Access Compliance Report

Public Rights-of-Way (Curb Ramps)

Intersection ID: 14281	Main Street: E_KINGSTON_AV	Cross Street: LYNDHURST_AV	Location:	W
ADA ID: A2C513B79119	Ramp Type: Directional1	Initial Pass/Fail: Fail	Overall Compliance: No	Severity Score: 12.5

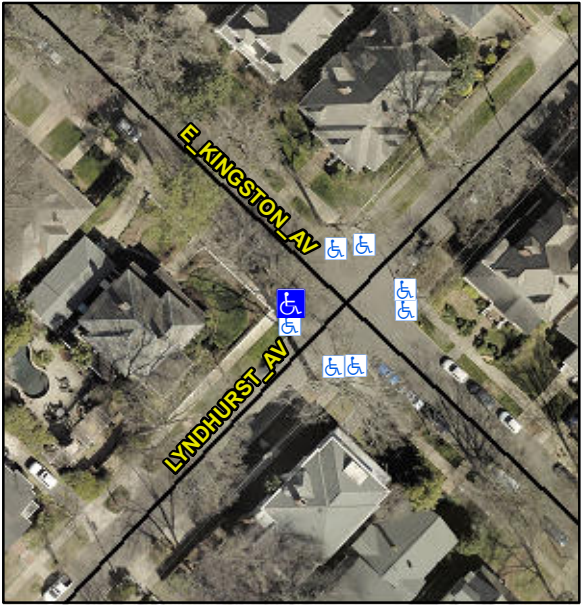
Codes/Mitigation Info/Possible Solution			Field Measurements/Component Compliance			
	Possible Solutions:		Compliance	Description	Data	
	Remove & Replace Entire Ramp.		N/A	Ramp Length (in)	64.0	N/A
			Yes	Ramp Width (in)	58.0	N/A
			Yes	Ramp Slope (%)	5.9	N/A
			No	Ramp XSlope (%)	5.1	N/A
			N/A	Flare Type LT	N/A	N/A
			N/A	Flare Slope LT (%)	N/A	N/A
			N/A	Flare Traversable LT?	N/A	N/A
			N/A	Landing Length (in)	0.0	N/A
			N/A	Landing Width (in)	0.0	N/A
			N/A	Landing Slope (%)	0.0	N/A
			N/A	Landing X Slope (%)	0.0	N/A
			N/A	Landing Curb? (Y/N)	N/A	N/A
			N/A	Shared Landing?	N/A	N/A
			N/A	Gutter Ponding?	0.0	N/A
			N/A	Gutter Lip Ht (in)	0.0	N/A
			N/A	Painted X Walk1?	No	N/A
				X Walk 1 Direction	To NE	N/A
				X Walk 1 Width (in)	N/A	N/A
				X Walk 1 Slope (%)	7.5	N/A
				X Walk 1 X Slope (%)	1.9	N/A
<p>Surveyor Notes:</p> <p>N/A</p>			N/A	Ramp inside XWalk1?	N/A	N/A
			N/A	Any Obstructions?	N/A	N/A
<p>PROW/ADA:</p> <p>R304.5.3</p>				Obstruction Type

Yes	Surface Condition? (G/P)		Good
			N/A	Curb Slope (%)		0.2
Street 1 Name	E KINGSTON AV					
Stop Condition-Street 1	None					
Street 2 Name	N/A					
Stop Condition-Street 2	N/A					
Total Cost:	\$	1600.00
